Access Compliance Report

Public Rights-of-Way

(Curb Ramps)

Intersection ID: 50272	Main Street: SOUTH_BV	Cross Street: WHITTON_ST	Location: NW
ADA ID: 62A1103E2024	Ramp Type: Perp	Initial Pass/Fail: Fail	Overall Compliance: No
Severity Score: 13.75			
Codes/Mitigation Info/Possible Solution		Field Measurements/Component Compliance

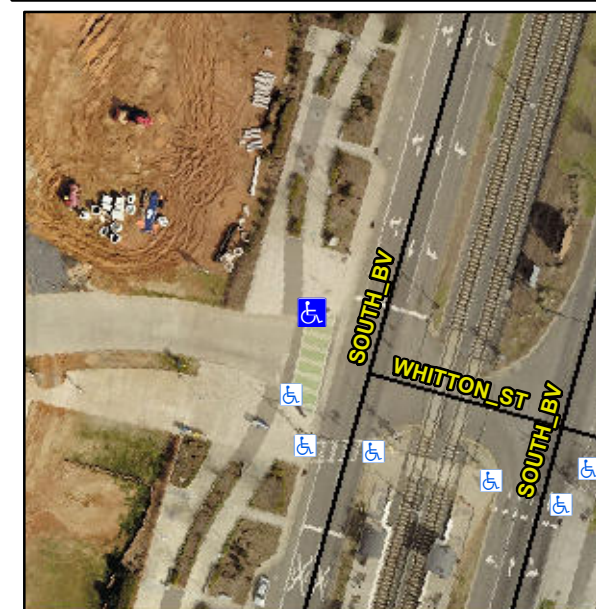
Not Found, R304.2.2, R304.5.3

Compliance	Description	Data	Compliance	Description	Data
N/A	Ramp Length (in)	70.0	No	Ramp Slope (%)	8.7
Yes	Ramp Width (in)	121.0	No	Ramp XSlope (%)	3.1
N/A	Flare Type LT	N/A	N/A	Flare Type RT	N/A
N/A	Flare Slope LT (%)	N/A	N/A	Flare Slope RT (%)	N/A
N/A	Flare Traversable LT?	N/A	N/A	Flare Traversable RT?	N/A
N/A	Landing Length (in)	N/A	N/A	DWS Provided?	N/A
N/A	Landing Width (in)	N/A	N/A	DWS Contrast?	N/A
N/A	Landing Slope (%)	N/A	N/A	DWS Length (in)	N/A
N/A	Landing X Slope (%)	N/A	N/A	DWS Full Width?	N/A
N/A	Landing Curb? (Y/N)	N/A	N/A	DWS Offset (in)	N/A
N/A	Shared Landing?	N/A			
N/A	Gutter Ponding?	N/A	N/A	Gutter Slope (%)	N/A
N/A	Gutter Lip Ht (in)	N/A	N/A	Gutter X Slope (%)	N/A
N/A	Painted X Walk1?	Yes	N/A	Painted X Walk2?	N/A
	X Walk 1 Direction	To SW		X Walk 2 Direction	N/A
N/A	X Walk 1 Width (in)	160.0	N/A	X Walk 2 Width (in)	N/A
	X Walk 1 Slope (%)	2.3		X Walk 2 Slope (%)	N/A
	X Walk 1 X Slope (%)	0.1		X Walk 2 X Slope (%)	N/A

Remove & Replace Entire Ramp.
